RE: Quarterly Inspection conducted on April 12, 2018

AFIN 18-00094

Permit Number 0245-S1-R1

Arkansas Department of Environmental Quality Office of Land Resources -Solid Waste Management Class 1 Landfill Inspection

Arkansas Department of Environmental Quality (ADEQ) Official Photograph Sheet

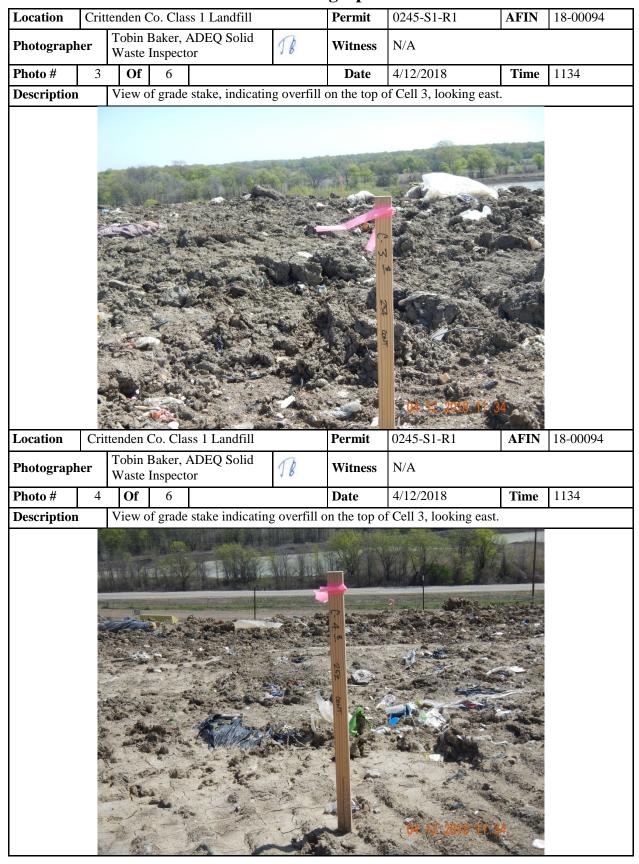
Regulation	Item Description	Comments
	411(a)	Operations in accordance with permit documents	
	417(c)	Adequate all weather operational roads	
X	411(c)	Smallest practical area, unloading supervised, single working face	The active working face was 240' X 60' which was not confined to the smallest practical area. (Refer to Photos #5 & #6.)
	411(e)	Salvage operations meet approved conditions	
	411(f)(1)	Scavenging of waste prohibited	
	411(p)	Proper wet weather repairs	
	411(b)	Operations by licensed on-site personnel at all times	
	411(d)	Waste spread and compacted as unloaded	
	411(g)	Litter control provisions maintained	
	414(a)	Disease vectors controlled

Cate	gory	2 (continued)				
	Regulation	Item Description		Comments					
	427	Surface Water Controls							
X	411(h)(1)	Contouring prevents surface water flowing into or three	ough waste		ace water was observed ser to Photo #2.)	standing	ng on top of the landfill in Cell 3, which was not contoured to drain.		
	418(a)(b)	Run-on/off control system present and adequate			,				
	411(h)(2)	Surface water control prevents off-site sediment accum	nulation						
	411(i);427(f)	Adequate maintenance of intermediate/final cover veg	etation						
	415	Gas monitoring program							
X	411(o)	Leachate leaks or evidence of leachate seepage		Leach	hate leaks were observed	d at the	e base of the east slope of Cell 1A. (Refer to Photo #1.)		
	426	Survey controls							
X	429	Leachate collection system					Cell 1A was not functioning at the time of this inspection. Chris Puckett ag on Friday (4/13/2018) morning to repair the leachate collection system

Location	Crit	tenden (Co. Clas	s 1 Landfill		Permit	0245-S1-R1	AFIN	18-00094
Photographer			Baker, A	ADEQ Solid or	TB	Witness	N/A	ı	1
Photo #	1	Of	6		1	Date	4/12/2018	Time	1113
Description		View o	of leacha	te leaks at the l	base of the	east slope	of Cell 1A, lookin	g north.	
							04 12 70/8 1		
Location	Crit	tenden (Co. Clas	ss 1 Landfill		Permit	0245-S1-R1	AFIN	18-00094
Photograph	J	Tobin 1		ADEQ Solid	18	Witness	N/A		
Photo #	2	Of	6		<u> </u>	Date	4/12/2018	Time	1131
Description		View o	of surfac	e water observe	ed standing	g on top of	the landfill in Cell	3, looking e	ast.

Corrective Action: Noted Allegations 411(h) (i) was corrected by fill and grading area, also by stopping heavy equipment from entering area.

Corrective Action: Regulation 411 (o) was corrected by digging out mattress and replacing void with cover.
